BALTIMORE COUNTY PUBLIC SCHOOLS

ADDENDUM NUMBER _1_

BID NAME: NEW SCHOOL CONSTRUCTION LANSDOWNE ELEMENTARY
SCHOOL/DEMOLITION OF LANSDOWNE ELEMENTARY
SCHOOL__

BID NUMBER: **MBU-516-17**

ADDENDUM #
1

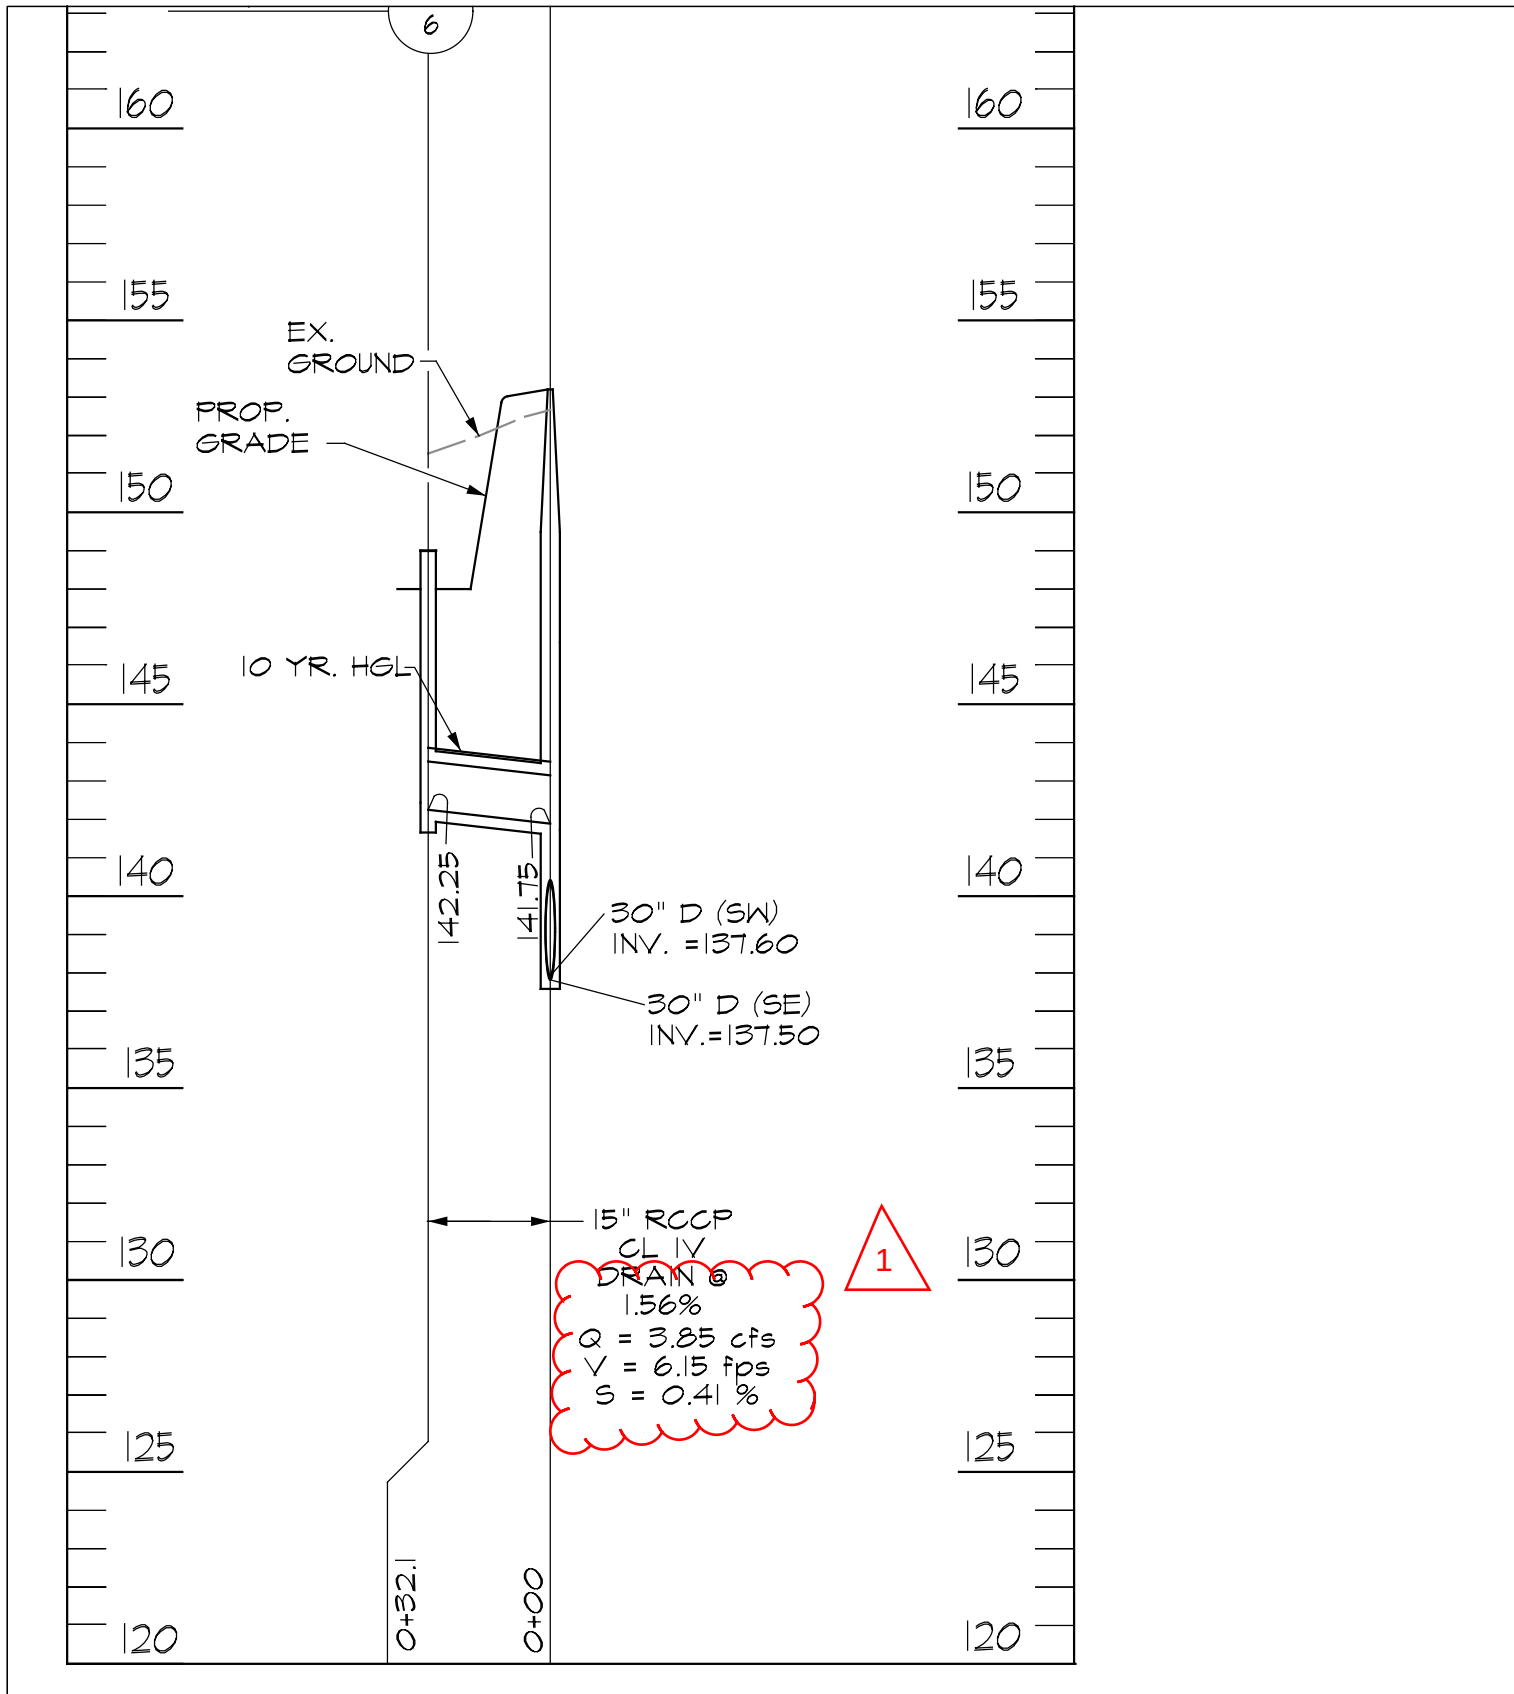
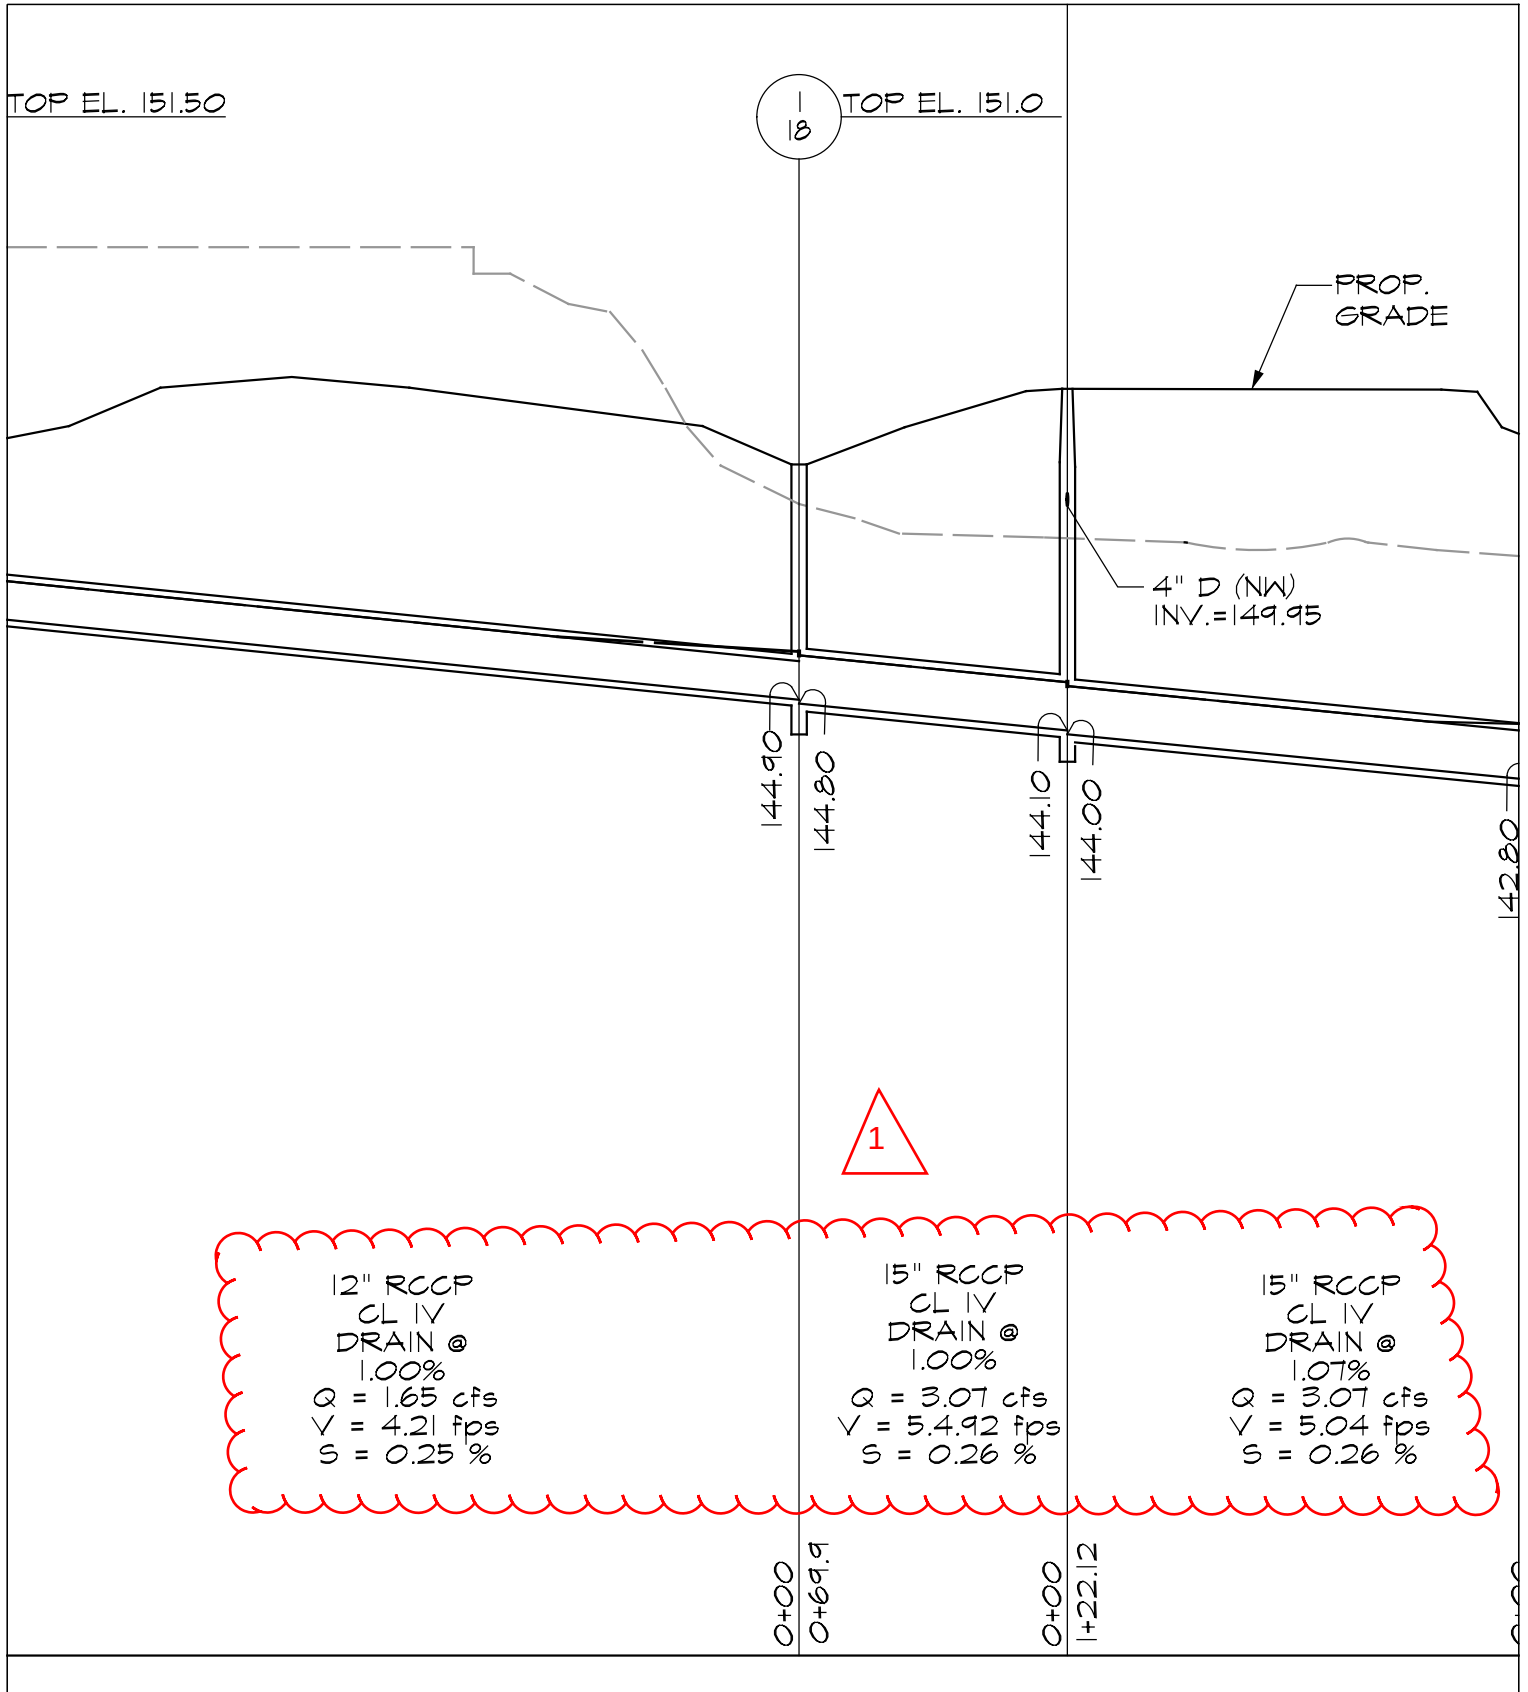
- 3.12. SHEET C-4.4, UTILITY PROFILES
REVISE: Storm Drain Profiles as indicated in attached sketches SK-C-11 – 11G.
- 3.13. SHEET C-4.5, UTILITY PROFILES
REVISE: Storm Drain Profiles as indicated in attached sketch SK-C-12 – 12E.
